SERVICE BULLETIN

No. 604A

Piper Aircraft Corporation

Subject: PART I: Forward Baggage Door Locking System Modification
PART II: Forward Baggage Door Lock Arm Assembly Inspection

SKETCH "A"

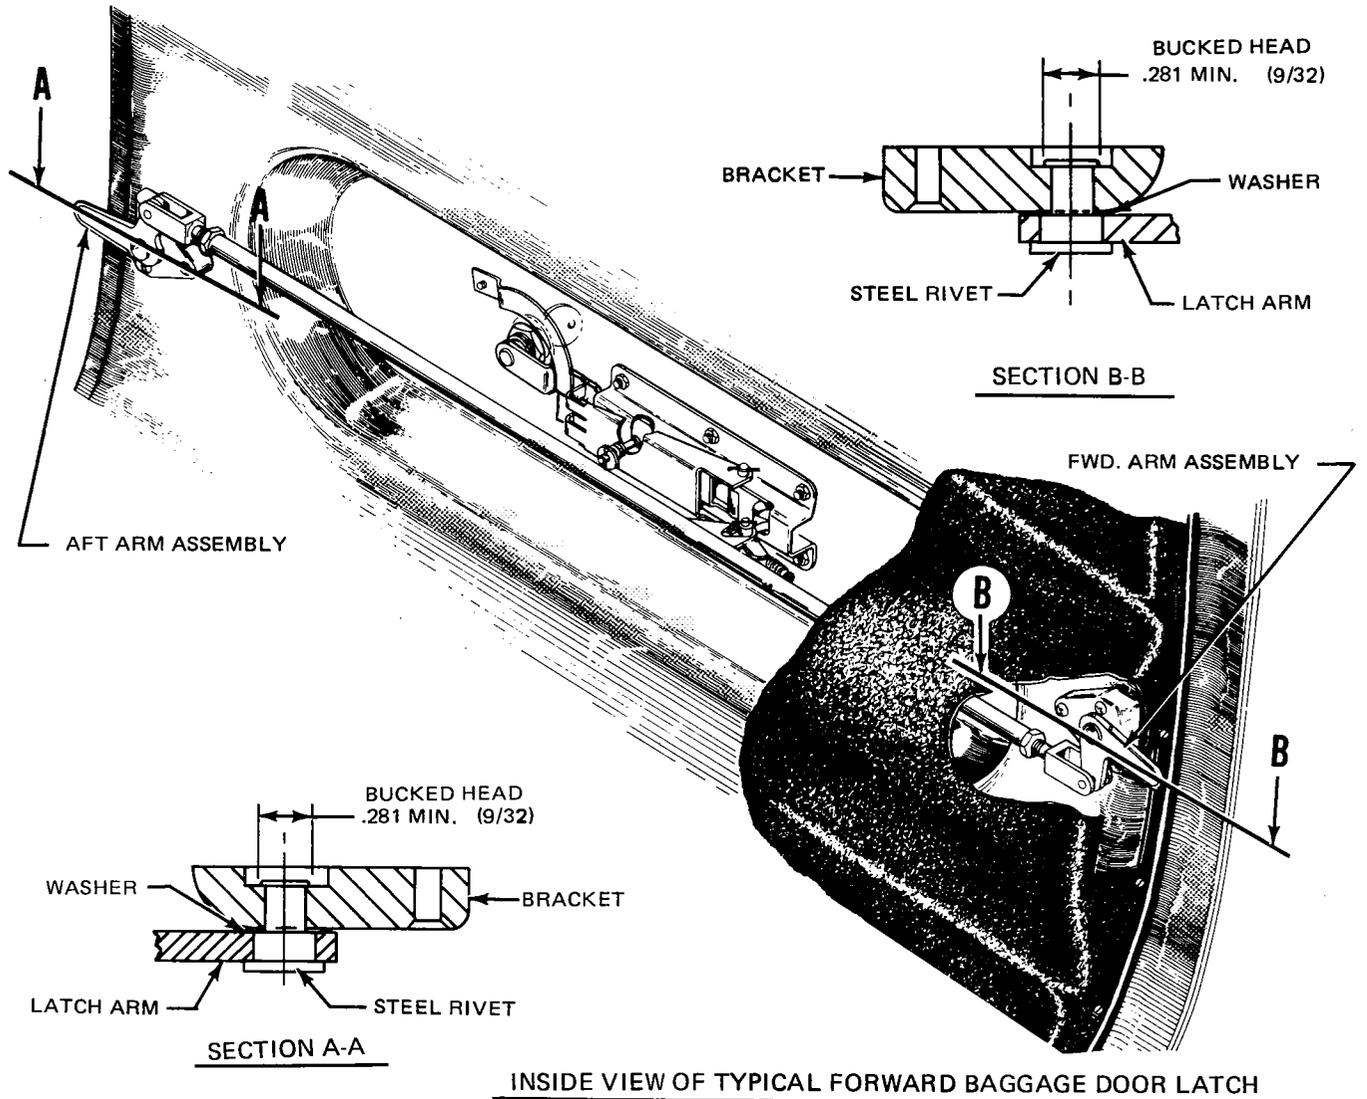
NOTE: Latch arm assemblies not retaining freedom of rotational movement, after head of rivet is peened, must be replaced with a new part as listed in Table below or steel rivet may be replaced as follows. (Refer to Sketch "A", Figure 1.)

- (1) Carefully drill out steel rivet. Maximum allowable hole size after drilling is . 267.
 - (2) Inspect the . 50 diameter counter bore in bracket to determine if counter bore is the proper depth as shown. Counter bore the hole to . 155 if it is not the proper depth.
 - (3) Install new rivet Part No. 22613-00 and peen in an acceptable manner to achieve a bucked head diameter of . 281 (9/32) or larger.

FIGURE 1

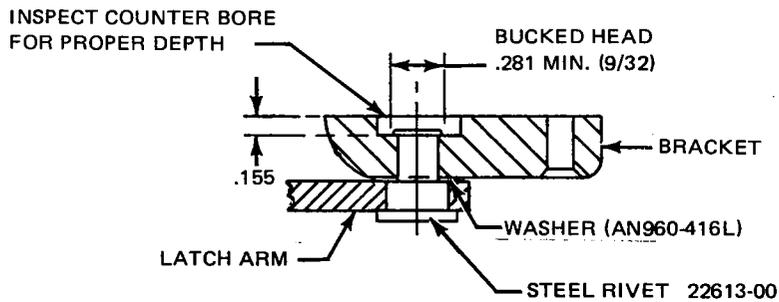
1. Refer to Section IV in the appropriate Service Manual and remove the door latch arm assemblies from the forward baggage door.
2. With the latch arm assemblies removed from the door, inspect as follows.
 - a. Measure the diameter of the bucked head of the steel rivet that secures the latch arm to the bracket (Refer to Section A-A and B-B on Sketch A). This diameter must be . 281 (9/32) or greater.
3. Latch arm assemblies with a bucked head diameter of . 281 (9/32) or greater may be considered acceptable.
4. Latch arm assemblies with a bucked head diameter of less than . 281 (9/32), must either be replaced with a new part as listed in the table below or may be reworked as follows.
 - a. Peen rivet head, in an acceptable manner, to achieve a bucked head diameter of . 281 (9/32) or greater, as shown.

NOTE: Latch arm assemblies not retaining freedom of rotational movement after rework, must be replaced with a new part as listed in Table below.
5. Install new or reworked latch arm assemblies to forward baggage door. Refer to Section IV in the appropriate Service Manual.
6. Make proper Logbook entry of Service Bulletin 604A "Part II" compliance.
